# SERVICE BULLETIN

Service Bulletin No.: DAC1-79-01 Rev 0

Title: Powerplant Cooling

- 1. ATA Code:** 7920
- 2. Effectivity:** All DA20-C1 Aircraft.
- 3. General:** This service bulletin addresses improvements to engine cooling, specifically the lowering of the engine oil temperatures when operating in high ambient temperature conditions.  
This service bulletin consists of two parts:

**Figure 1**  
Apron Baffle Sealing

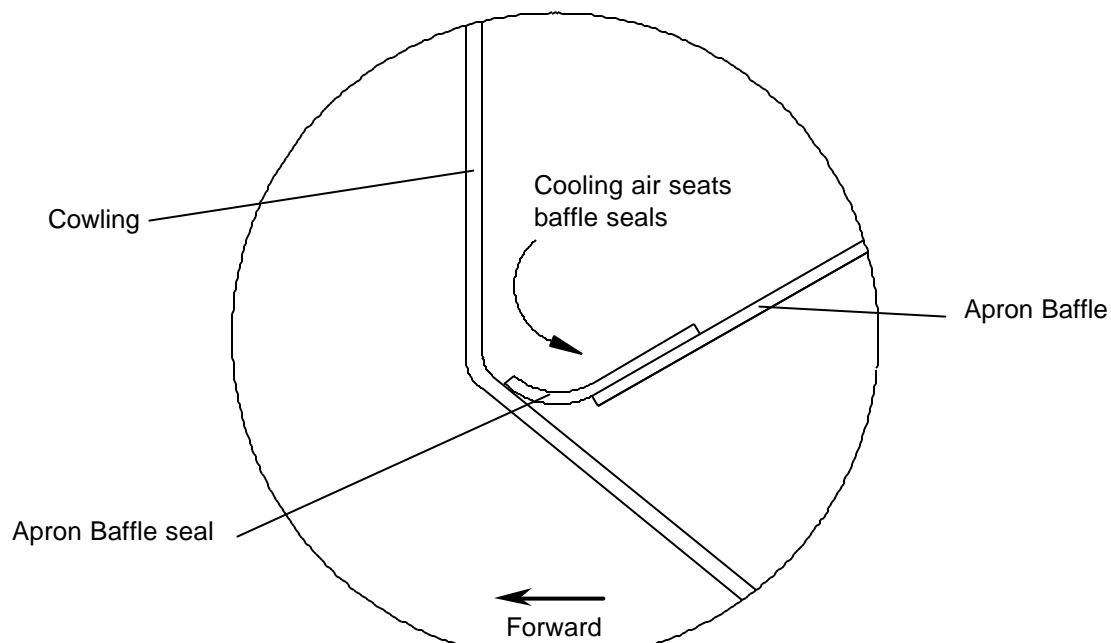
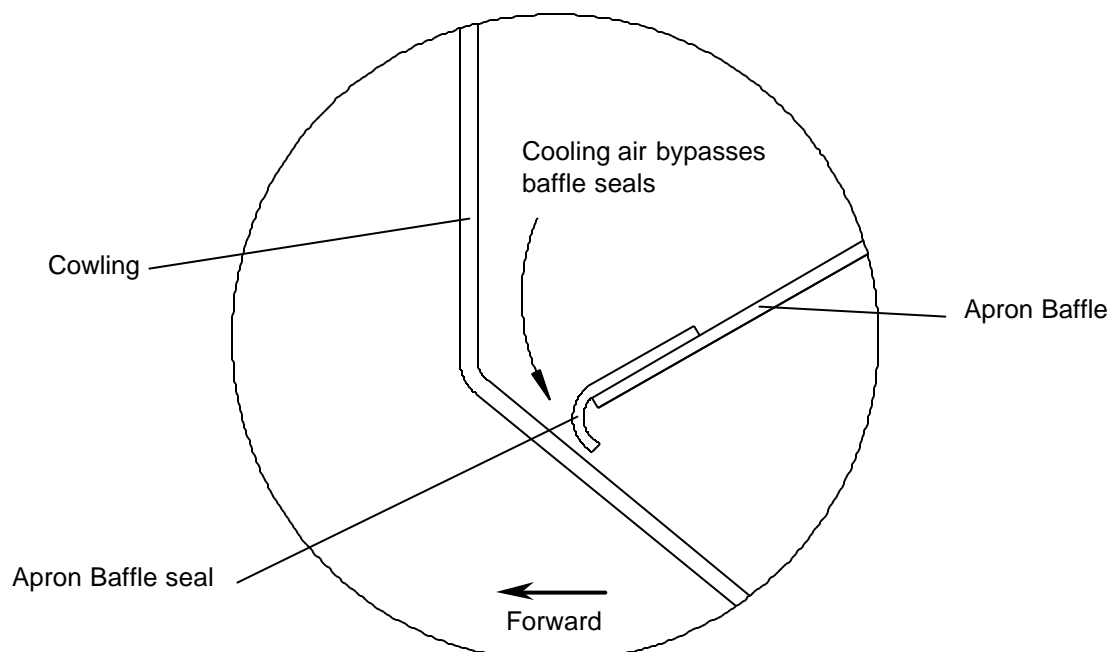
**10.1 Part One:** For efficient and consistent airflow through the cooling passages, it is important to ensure the correct alignment of the baffle seals. All unfastened seal edges must be turned toward the inside of the cooling passages (Figure 1). This is particularly important in the areas where the seal goes around sharp corners like the extreme left and right edges of the apron baffle.

**10.1.1.1** The unfastened seal edges should seat on the cowling as shown in Figure 1a.

**Figure 2**  
Apron Baffle Support Bracket

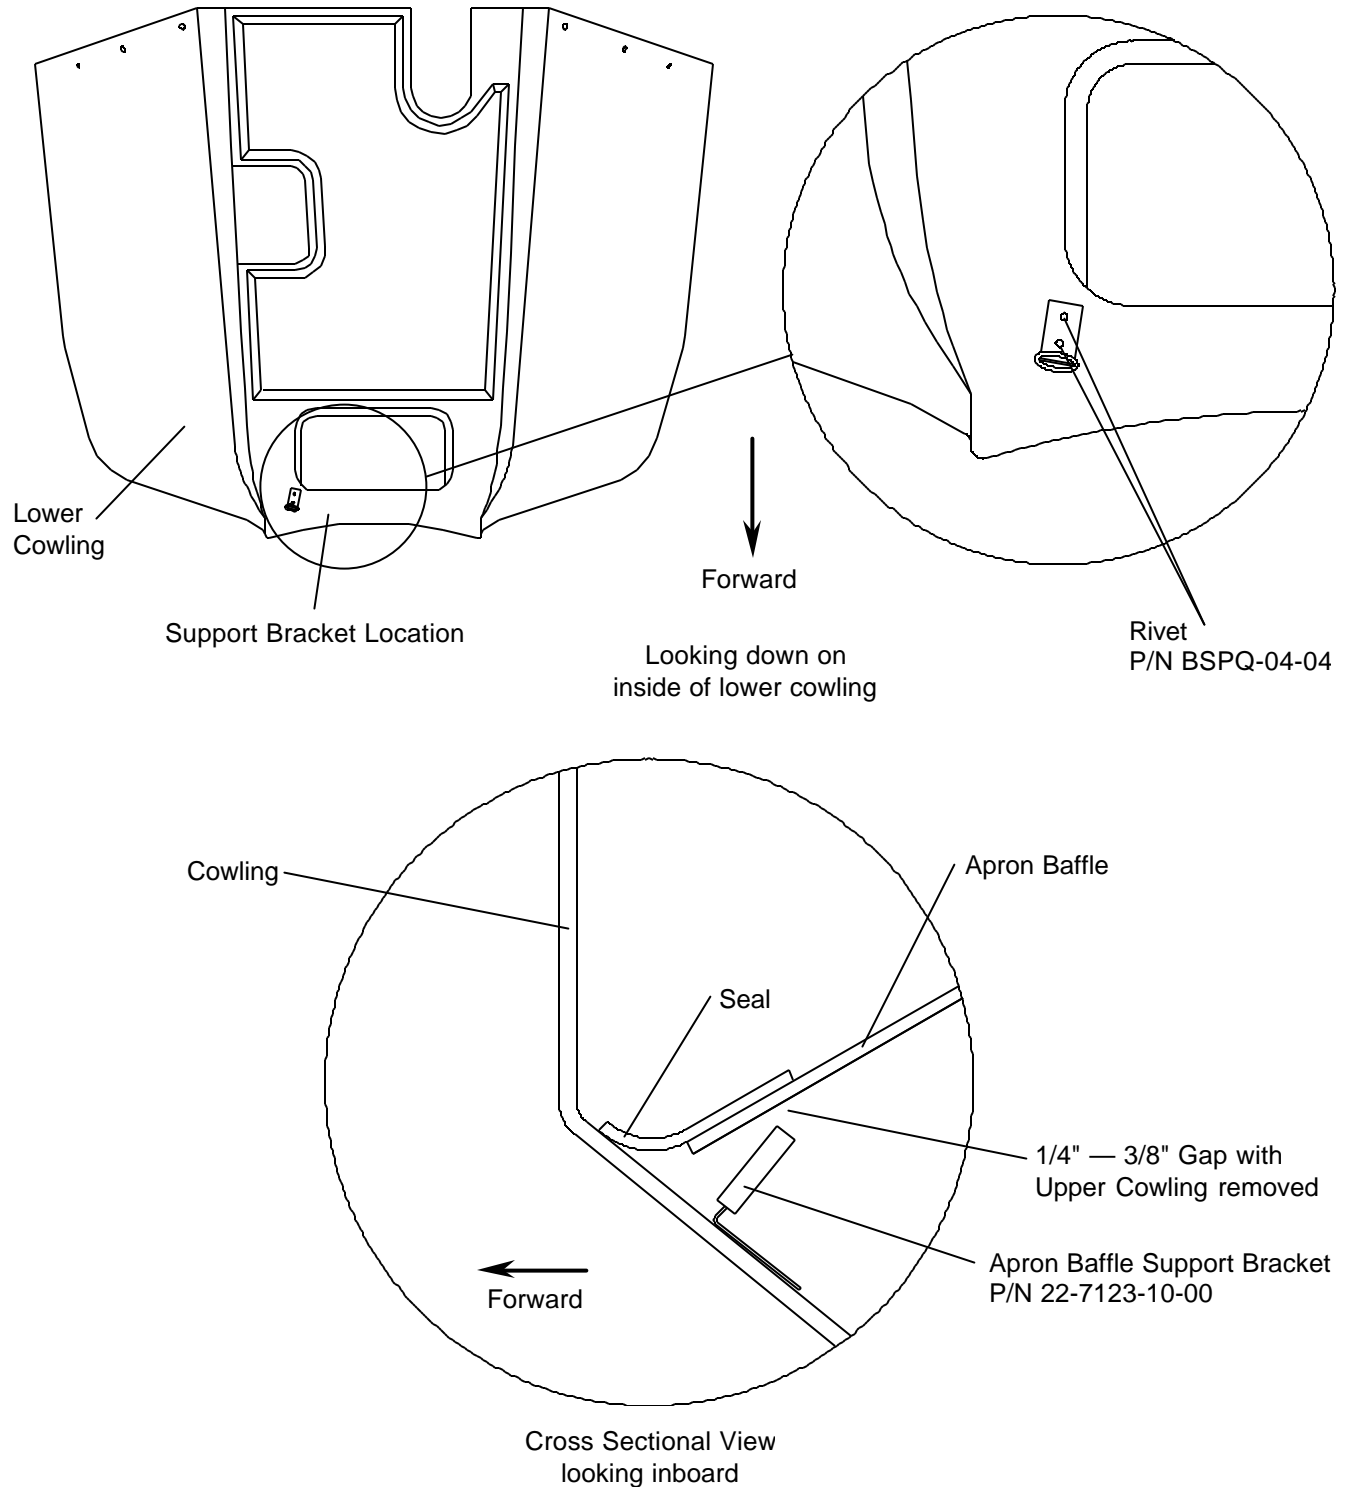
- 10.1.3.1 Remove the upper cowling.
      - 10.1.3.2 Put the Apron Baffle Support Bracket (P/N 22-7123-10-00) in its correct position (Figure 2) and temporarily fasten it to the cowling with adhesive tape. Ensure the support bracket is aligned as square as possible to the surface of the apron baffle and leave a gap of 1/4" to 3/8" between the tip of bracket and the underside of the baffle.

- 10.1.3.5 Install the bracket with two rivets (P/N BSPQ-04-04) (Figure 2).
      - 10.1.3.6 Install the lower and upper cowlings. Ensure all the seal edges are turned in toward the cooling passages.

**Figure 3**  
Apron Baffle Seals

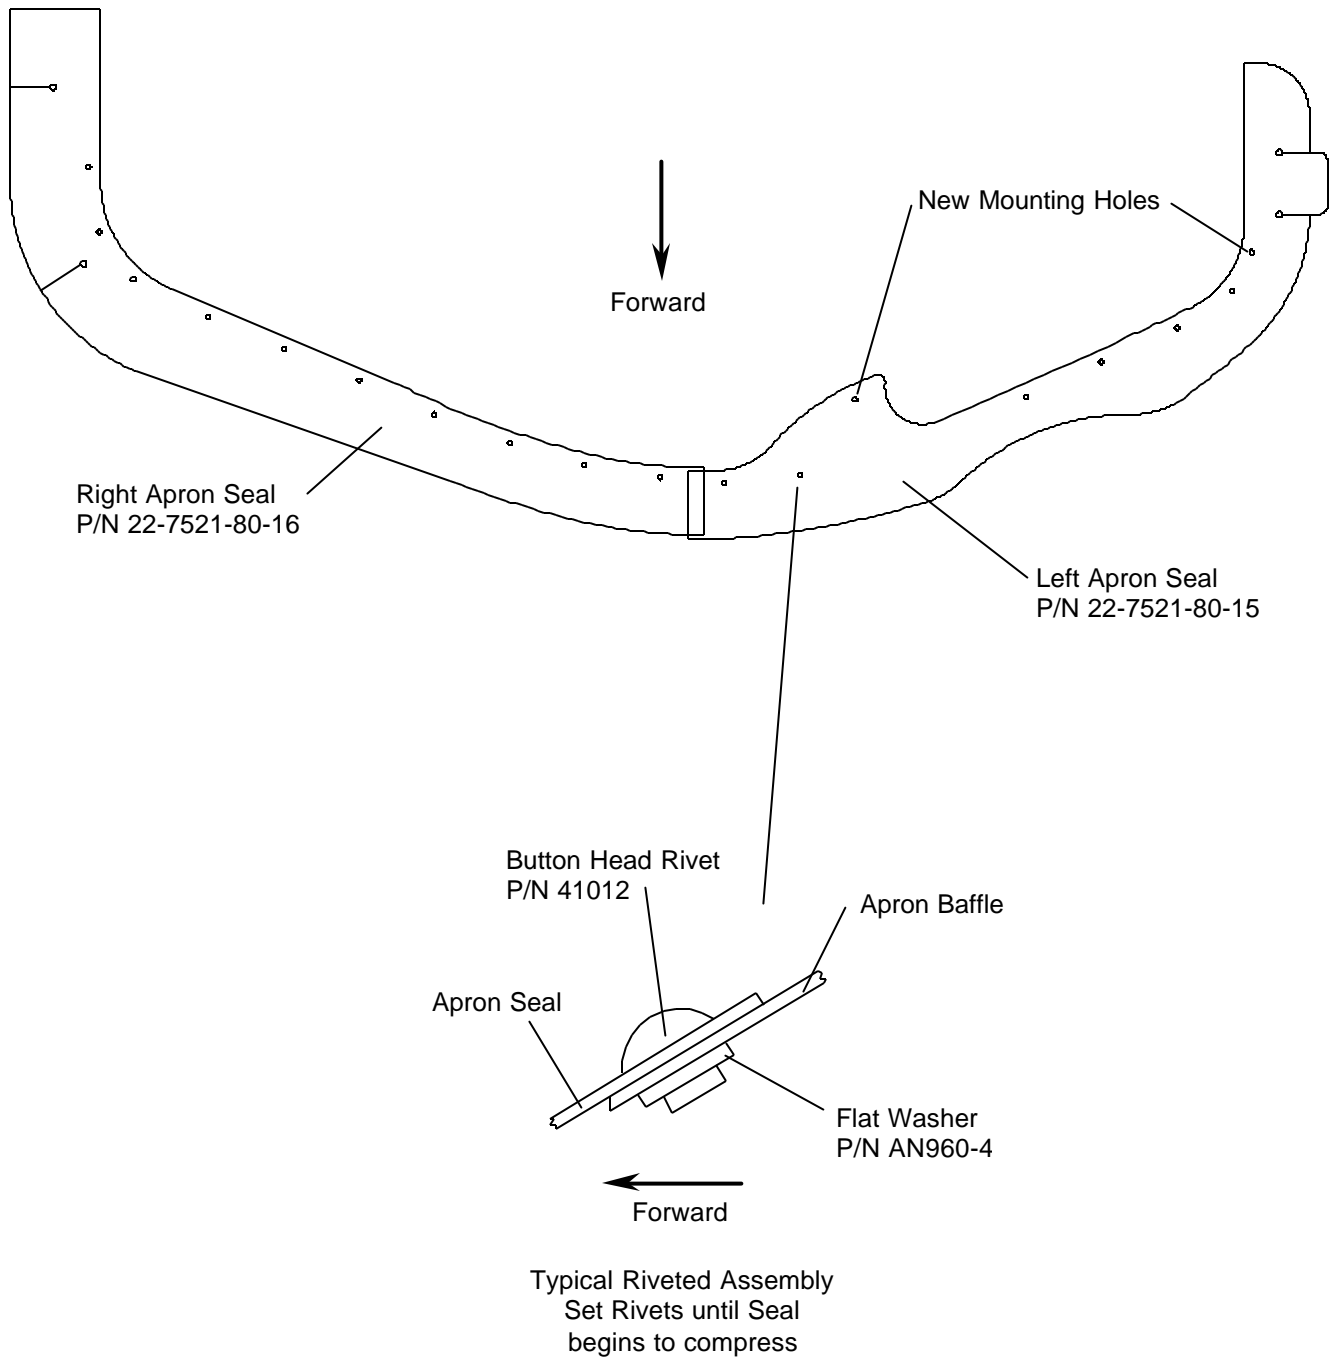
**10.1.1.2** If the seating is unsatisfactory, an improved fitting baffle seal configuration (Figure 3) is available. Installation of these seals is detailed in 10.1.2

**10.1.2.4** Install the right Apron Baffle Seal (P/N 22-7521-80-16) and the left Apron Baffle Seal (P/N 22-7521-80-15) by stretching each hole over its matching existing rivet head. Use the Left Apron Baffle Seal as a template to drill the two new mounting holes in the apron (Figure 3). Install the rivets (P/N BPSQ-04-04) and the washers (P/N AN960-4) into the new holes.

**Figure 4**  
Aft Baffle Oil Cooler Air Inlet

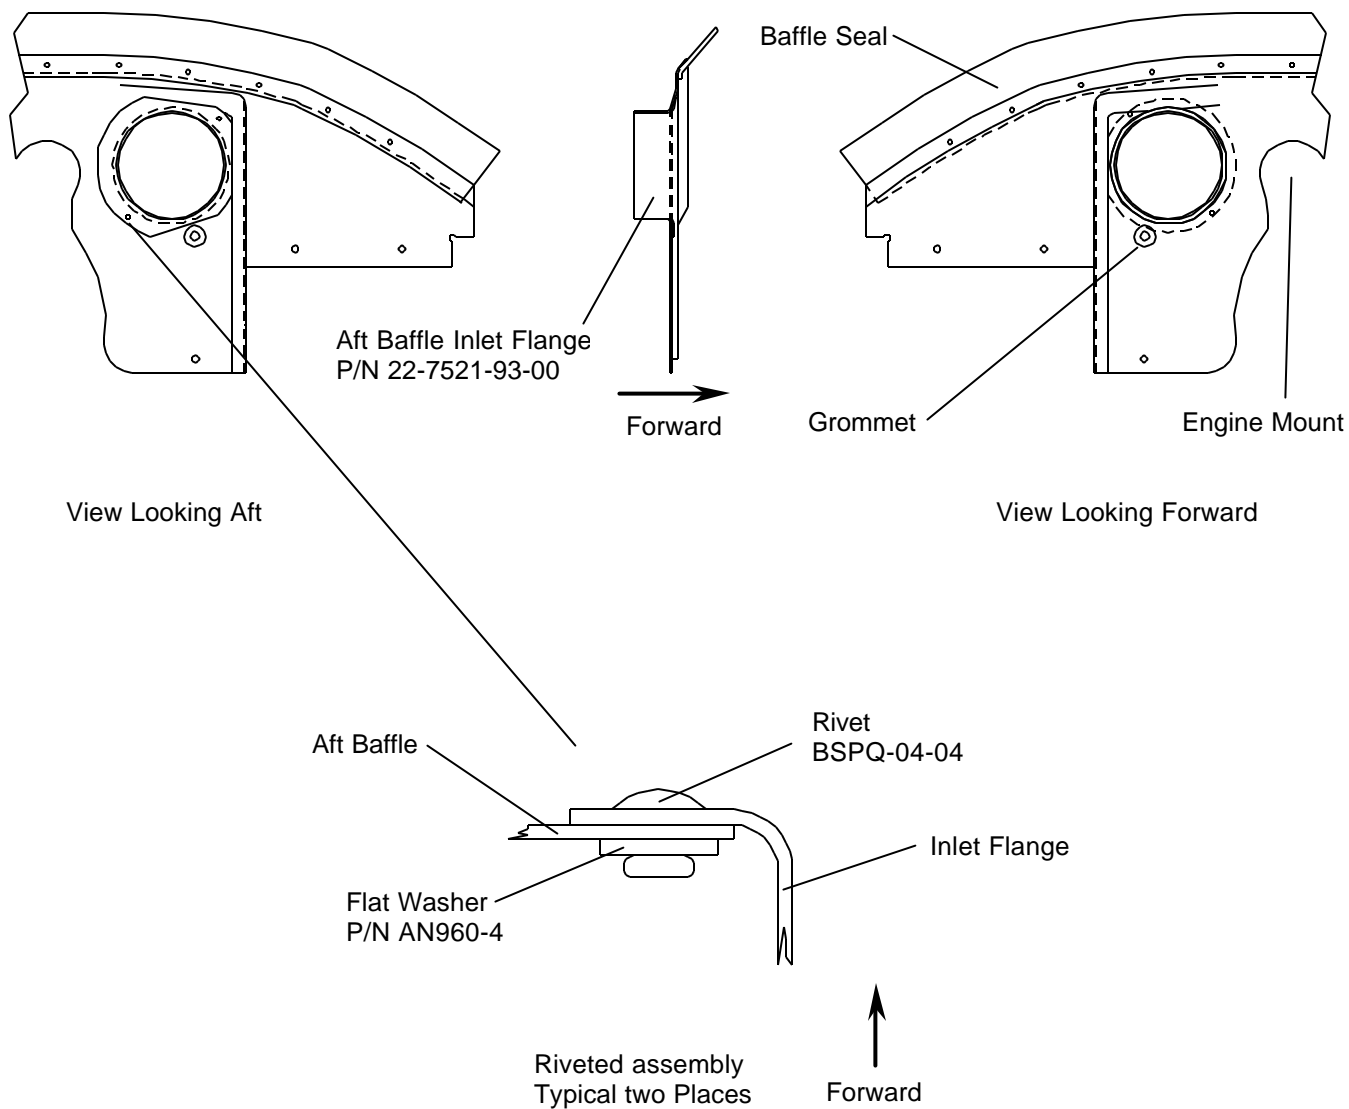
- 10.2.3.2 Grind off the existing Oil Cooler Inlet Flange.
      - 10.2.3.3 Open the hole in the baffle to allow the new Inlet Flange (P/N 22-7521-93-00) to fit through from the front. The hole must be moved outboard (approx. 1/8") and down (approx. 3/16") to avoid the baffle seal, the engine mount, and the grommet (Figure 4).

- 10.2.3.6 Drill the two holes (#30 drill bit) for the rivets. Locate around the circumference as required to fit.
      - 10.2.3.7 Bond the Inlet Flange to the front side of the baffle using DP110 adhesive and fasten with the rivets (P/N BSPQ-04-04) and the washers (P/N AN960-4) (Figure 4).

**10.2.4.2** Align the Drill Guide Template on the firewall (Figure 4) and drill the four holes (#10 drill bit) through the firewall.

**10.2.4.3** Install the higher capacity Oil Cooler Assembly (P/N 22-7923-01-00) at the four new holes with indicated hardware (Figure 4).

**Figure 5**  
Oil Cooler Mounting

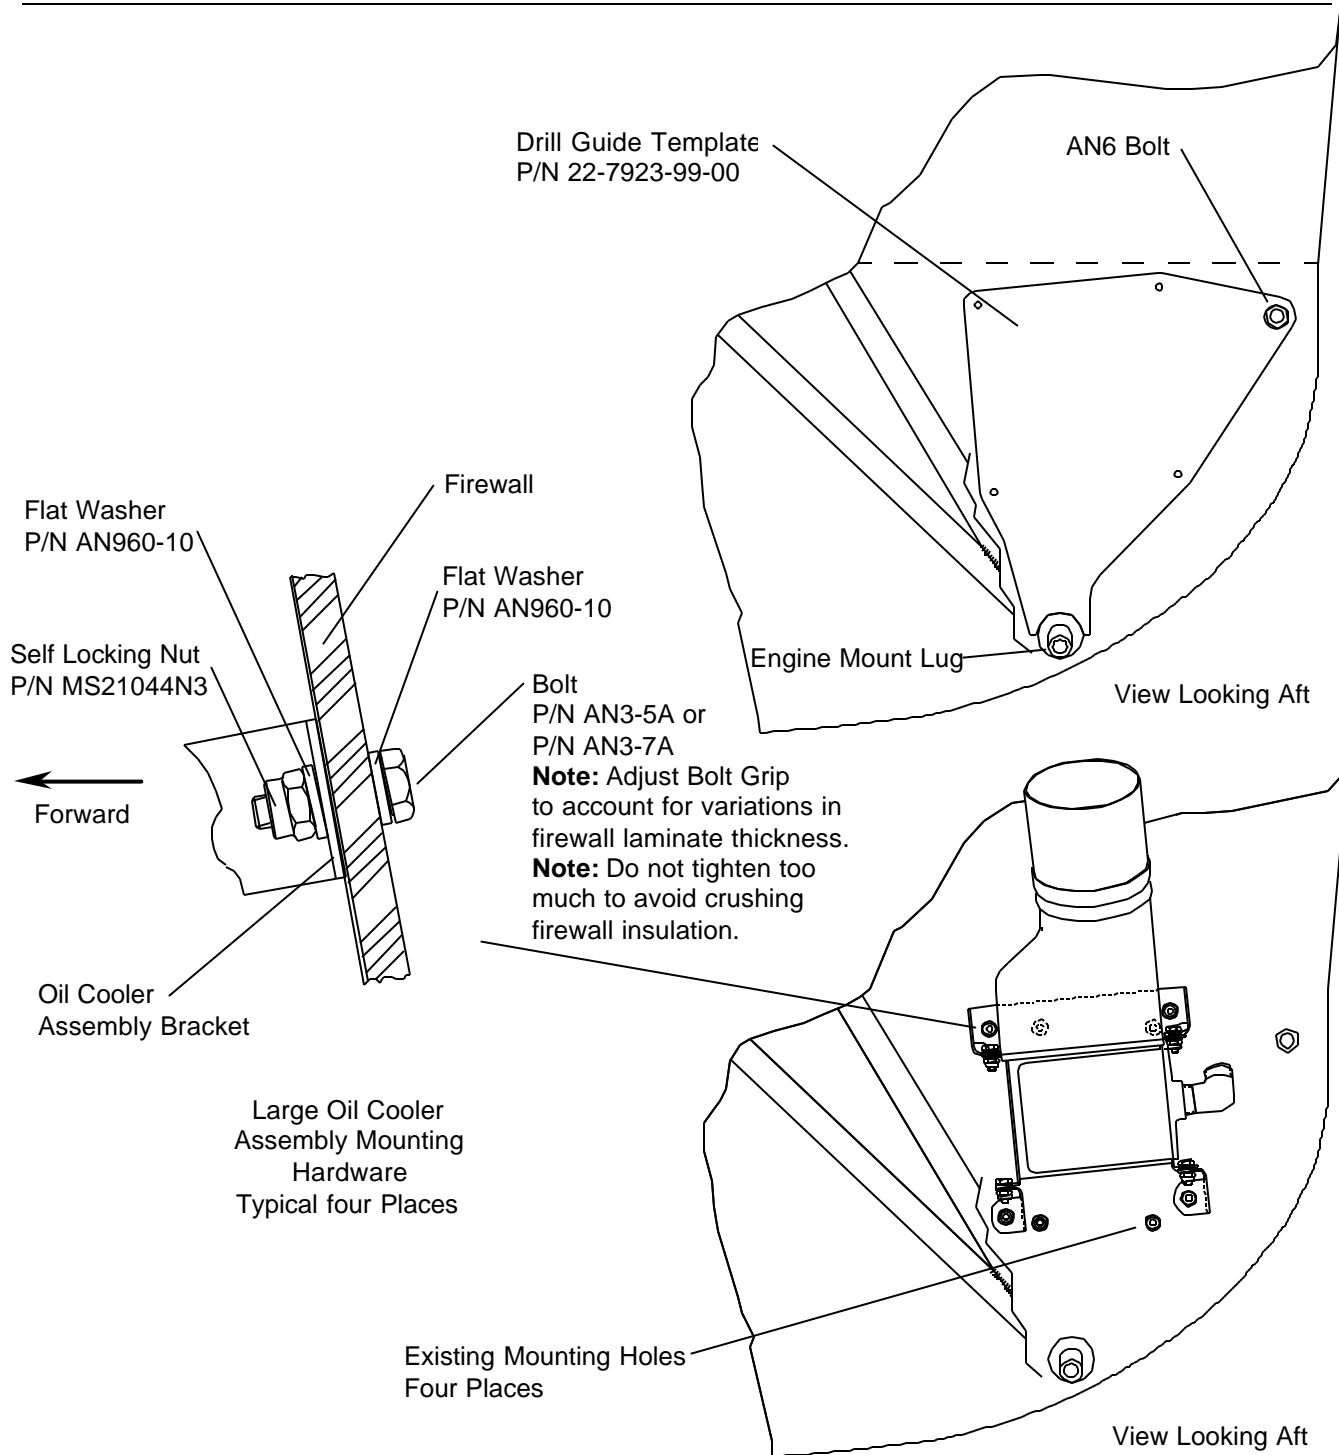
**10.2.4.6** Install the Oil Cooler Duct Hose (P/N 22-7923-00-01) with the two hose clamps (P/N 079-810 ) (Figure 5).

**Figure 6**  
Oil Cooler Assembly Installation  
General View

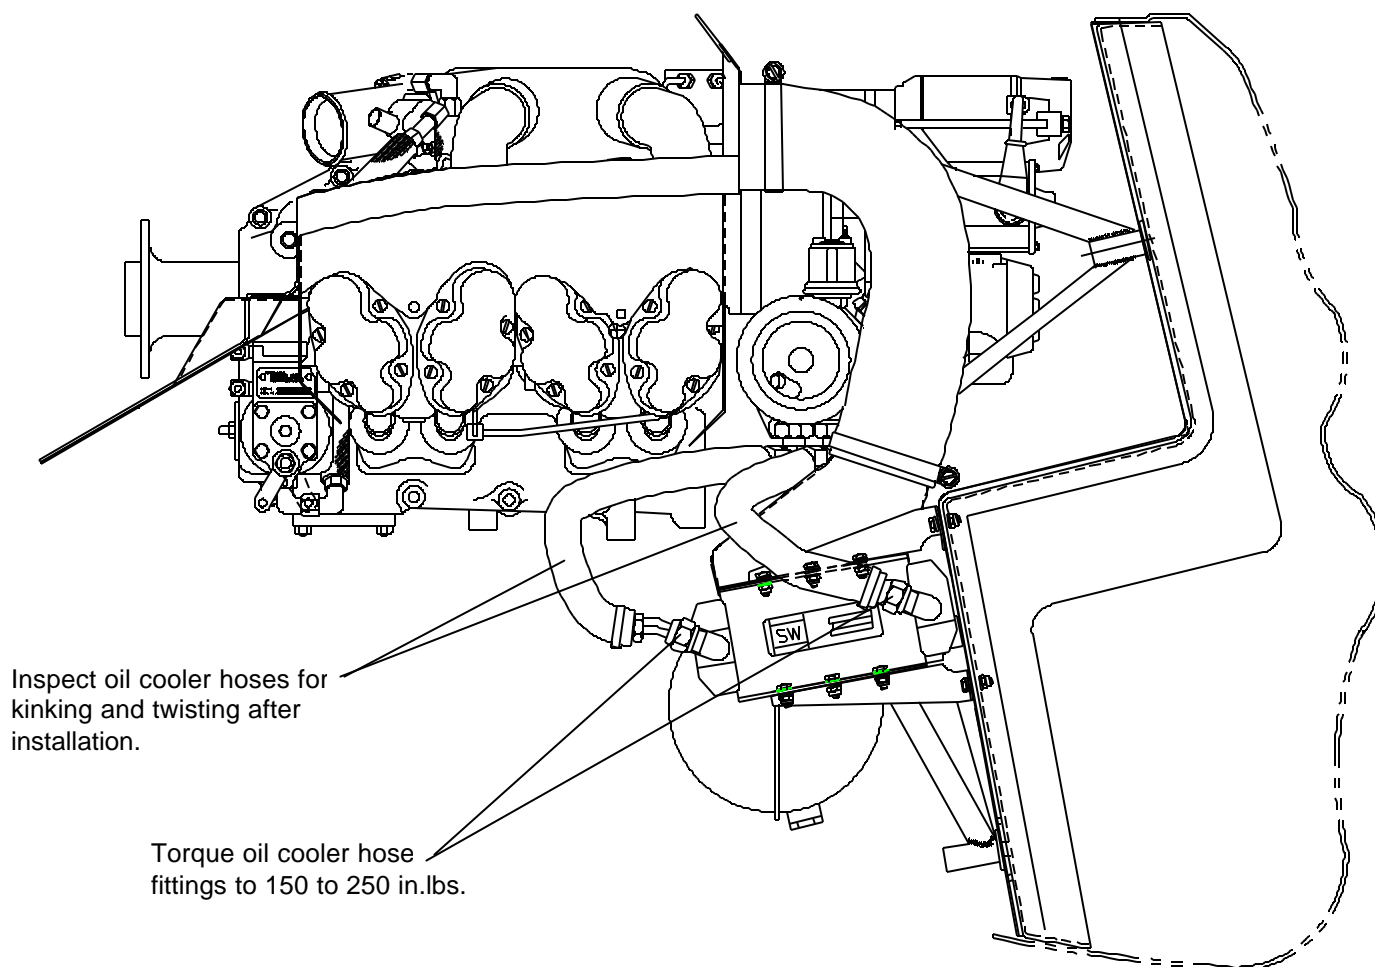
**10.2.4.7** Torque the oil cooler hose fittings to 150 to 250 in.lbs. (Figure 6) (MM Chap. 79-00-00).
